Re: Indian Point Unit No. 2
Docket No. 50-247

SUBJECT: Reply to Request for Additional Information
Passive Autocatalytic Recombiners

Reference: Proposed Technical Specification for H2 Recombiners.

**RESPONSE
TO
REQUEST FOR ADDITIONAL INFORMATION**

Figure 2-1 -- Evaluation of PAR Chemical Environment

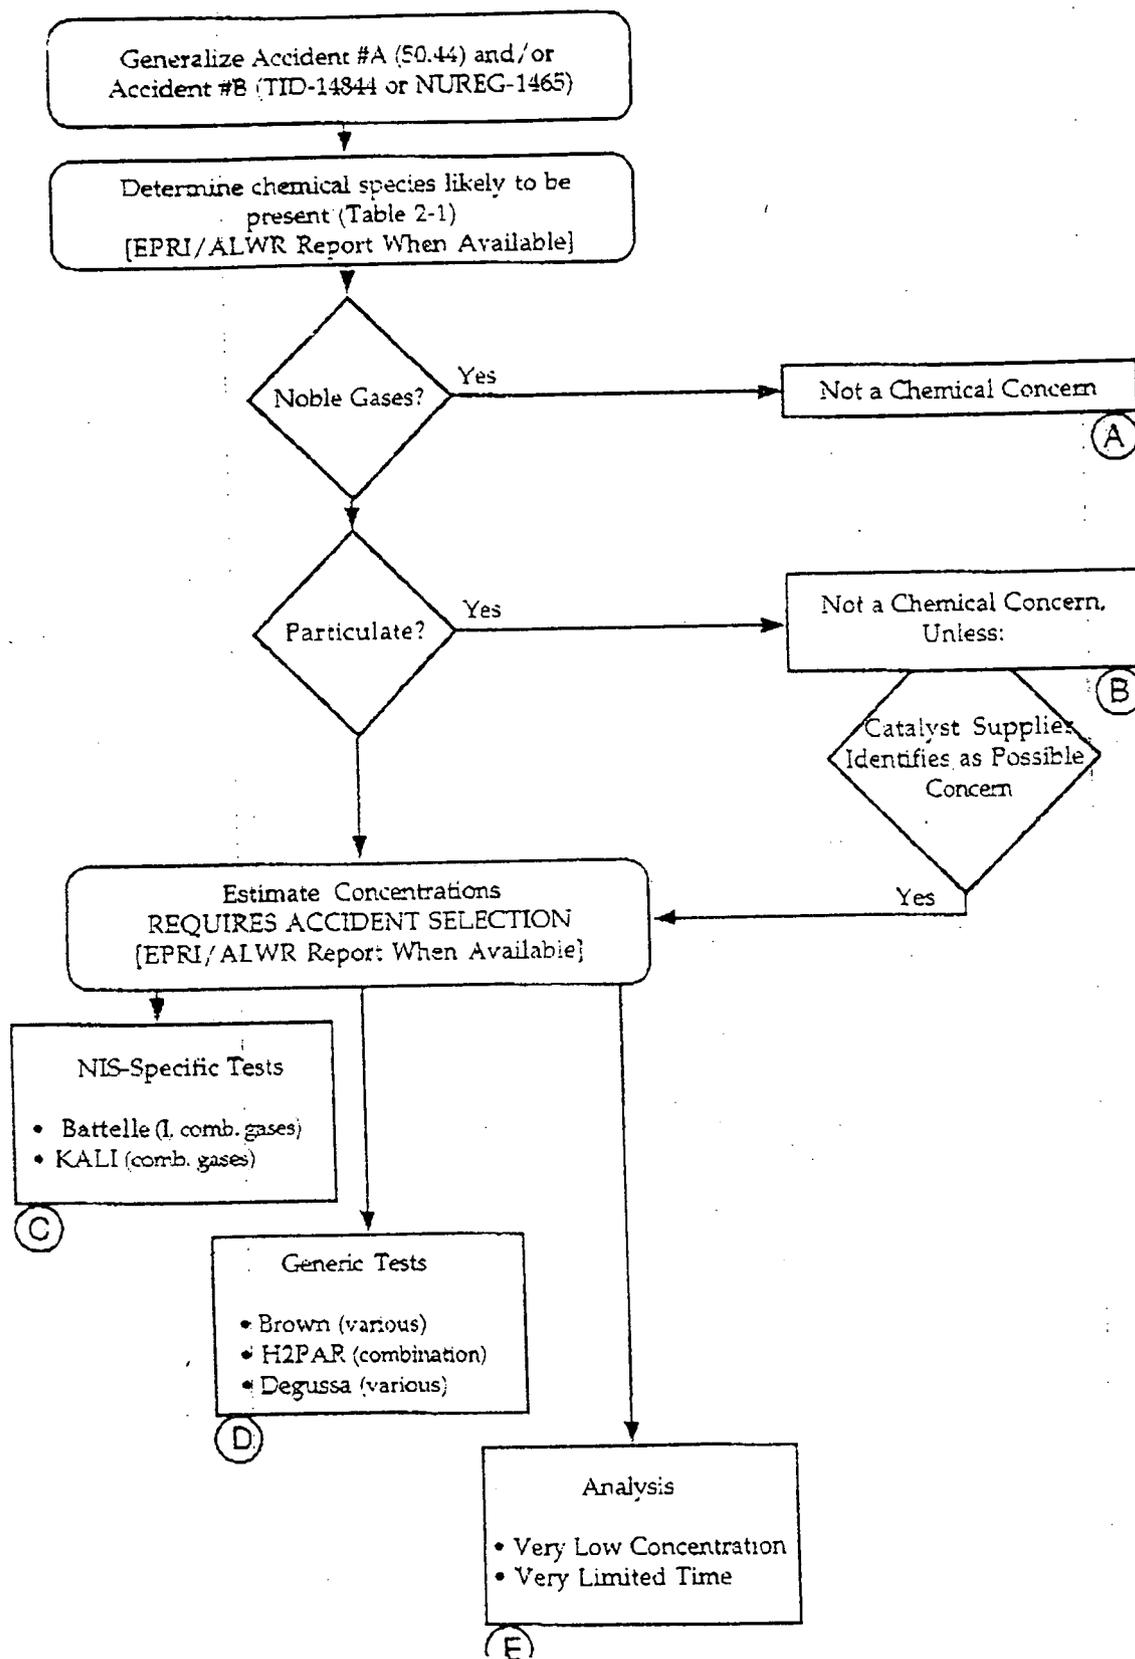
- 2) How are you going to determine the effect the following fission products would have on the ability of the palladium catalyst to recombine hydrogen and oxygen: (1) xenon, (2) krypton, (3) bromine, (4) methyl iodine, (5) cesium, (6) rubidium, (7) tellurium, (8) antimony, and (9) selenium?

Attached figure 2-1 represents the logic used by PAR developers.

First, clad- or core-damaging accident scenarios were studied for an understanding of the likely constituents of the post-accident containment environment. Because PARs were developed for severe accident service, core melt accidents were generally assumed such as those represented by TID-14844 or NUREG-1465 radiation source terms. Next, because accident radiation source term work generally centered on radioactive fission product elements released to the containment, lists of resulting chemical species as well as of non-radioactive accident chemicals were needed.

From this list of potentially present chemicals, noble gases were immediately removed as possible inhibitors because such gases are not generally reactive and certainly not with noble metal catalysts. (Disposition "A" on Figure 2-1).

Next, particulate forms of potentially present chemicals were removed from consideration as chemical inhibitors because their physical form prevented them from significant chemical interaction with the noble metal catalyst sites. (See the response to questions 13 and 14 for discussion of "physical" inhibition by particulates and debris.) For added assurance, the supplier of the particular catalyst was asked to verify that they had no evidence of chemical poisoning by particulate forms of such chemicals, for example by revaporization at elevated temperatures. (Disposition "B" on Figure 2-1)

The chemicals remaining on the list needed to be dispositioned in one of three manners:

- * Testing of the inhibition chemical at expected concentrations with the specific catalyst used. (Disposition "C" on Figure 2-1.)
- * Review of test data from testing on comparable catalysts. (Disposition "D" on Figure 2-1.)
- * Analysis that significant chemical damage to the catalyst would not occur, generally due to low concentrations present or limited time for the presence of chemicals or both. (Disposition "E" on Figure 2-1.)

For the development of the NIS Ingenieugesellschaft mbH (NIS) PAR only gaseous forms of iodine and mixtures of combustion gases were specifically tested (Disposition "C".) Nevertheless, Figure 2-1 indicates other possible dispositions for other chemicals. As described below, EPRI work (ref. 5) largely validates the overall list of potentially present inhibitors and should describe which additional chemicals can be assigned to Disposition "C" or "D".

FIGURE 4-1

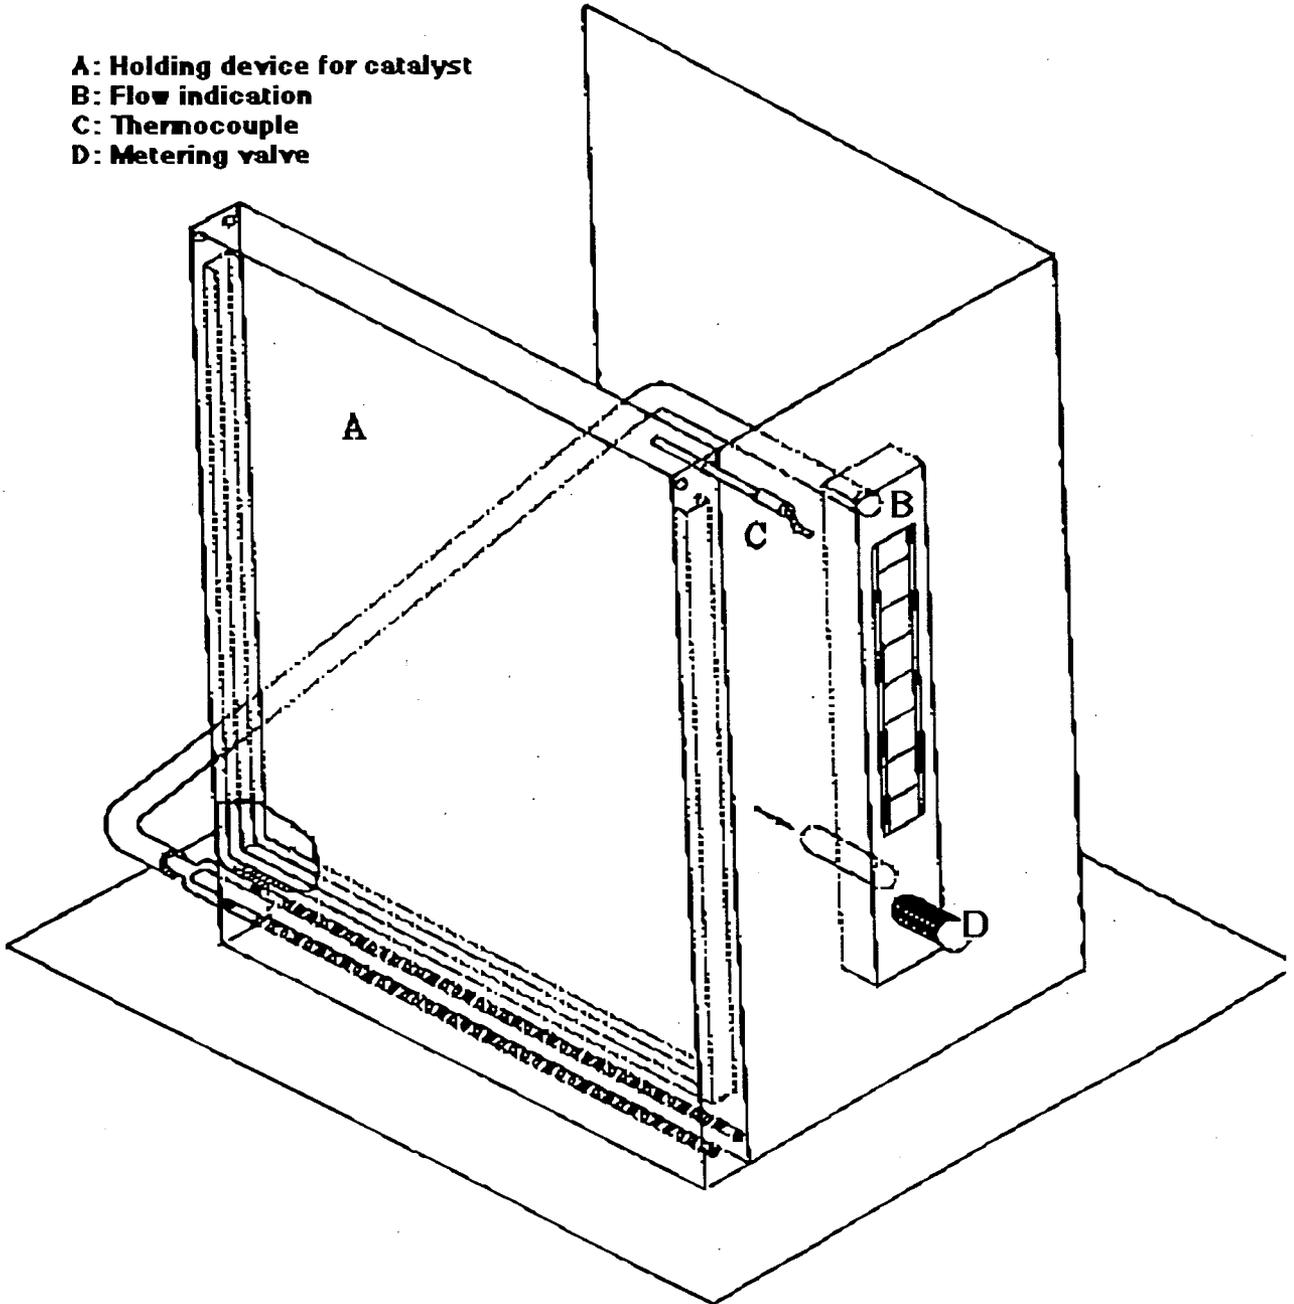
- 4) The submittal states that periodic surveillance will confirm that unexpected degradation does not go undetected. Provide a description of the proposed surveillance and the basis for the corresponding exit temperature for a particular hydrogen mixture test gas. What additional surveillances will be done if the sample plate tested should fail? This should be incorporated into the revised safety analysis report

Periodic surveillance will consist of visual examination plus testing of individual plates for indication of significant change in response to a known hydrogen gas mixture. This technique was developed by NIS and was also used by Wyle Laboratories in testing the effects of radiation on a single plate (ref-1).

The individual plate is inserted into the test chamber (see figure 4-1) and a known flow of 1%-hydrogen-in-air is injected into the chamber. The plate outlet temperature is measured and compared with measurements on new plates. The plate will be judged to be undegraded if the temperature developed is within the acceptable criteria. The acceptance criteria is being developed in baseline testing for the NIS test equipment.

Since there are no known or expected aging or degradation mechanisms to specifically examine, this comparative testing is considered adequate to detect unexpected changes in reaction rate of catalyst plates well prior to unacceptable deterioration in overall performance.

If a plate were to fail this surveillance the response would be determination and correction of the root cause of the failure.

FIGURE 12-1

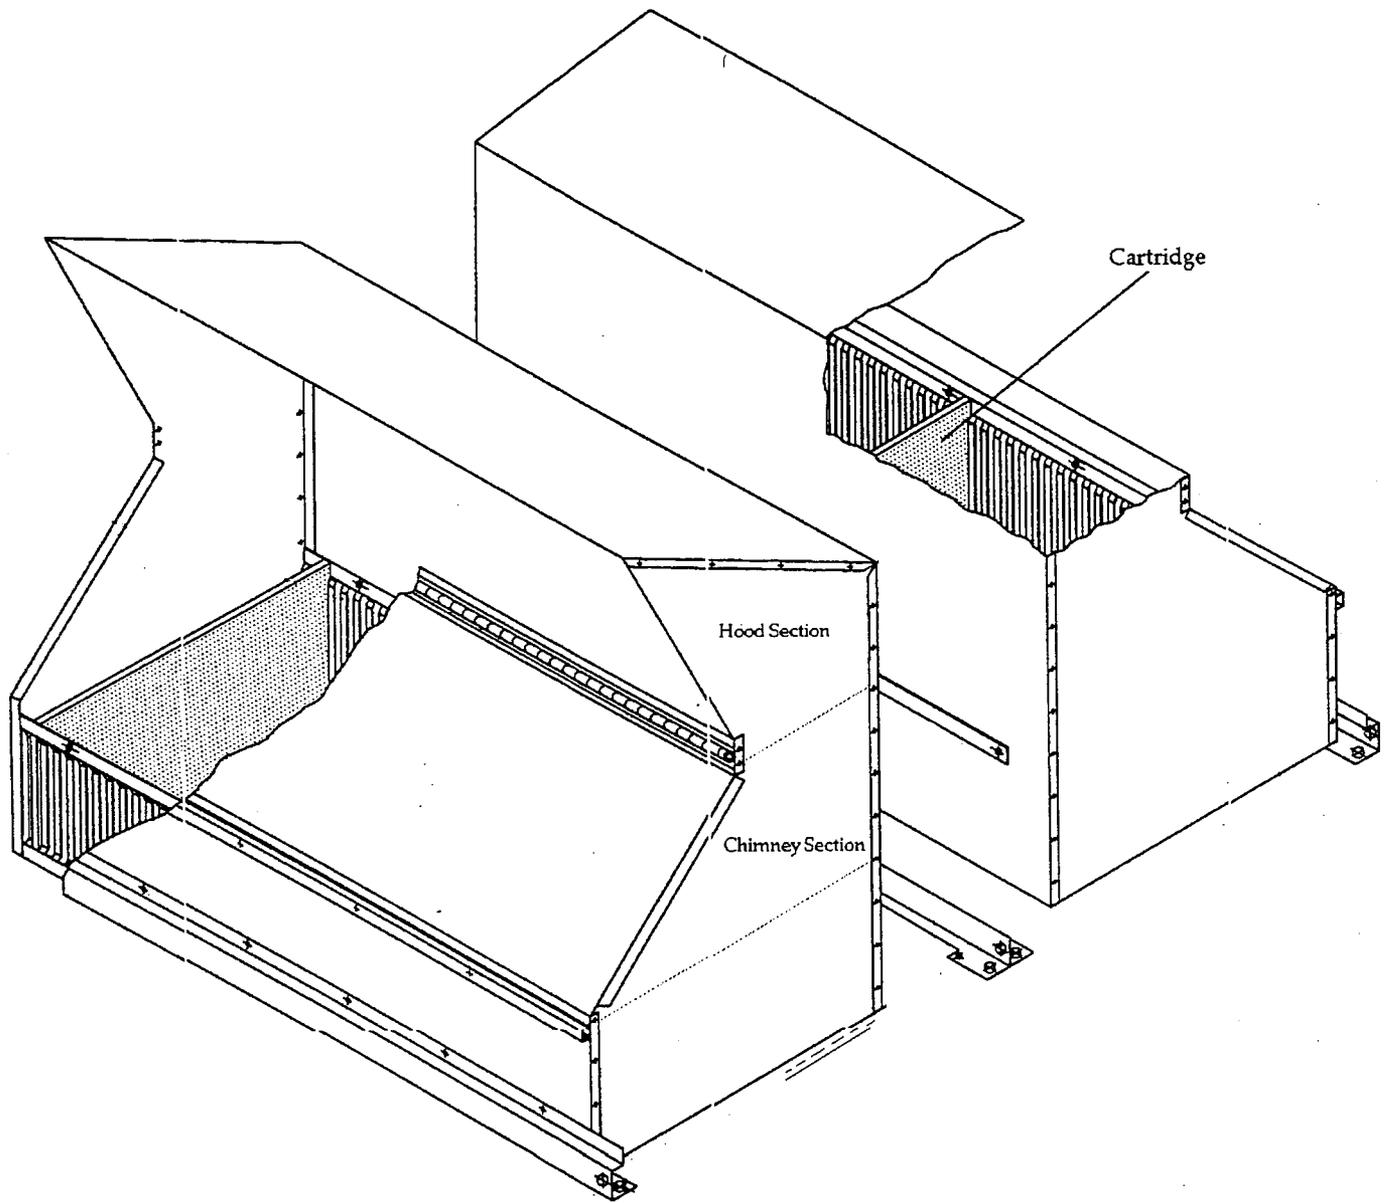
- 12) What affect will the containment spray hood have on PAR performance? What affect would chemical additives in the containment spray have on PAR performance?

The PAR configuration that is being installed at IP2 is shown in figure 12-1.

The spray hood is expected to have a neutral to positive effect on PAR gas flow rate compared with test configurations used for validation noted in question #8. Such testing was done without the spray hood. Calculations done by NIS have indicated a very minor theoretical decrease in flow due to the turning-portion of the hood but that decrease is significantly less than the increase of flow due to the height of the spray hood itself.

Wyle will be conducting tests using plant specific chemical spray which are expected to indicate that the spray chemical additives do not have a significant impact on the reaction of a PAR section with hydrogen. NIS is conducting similar "single cartridge" testing.
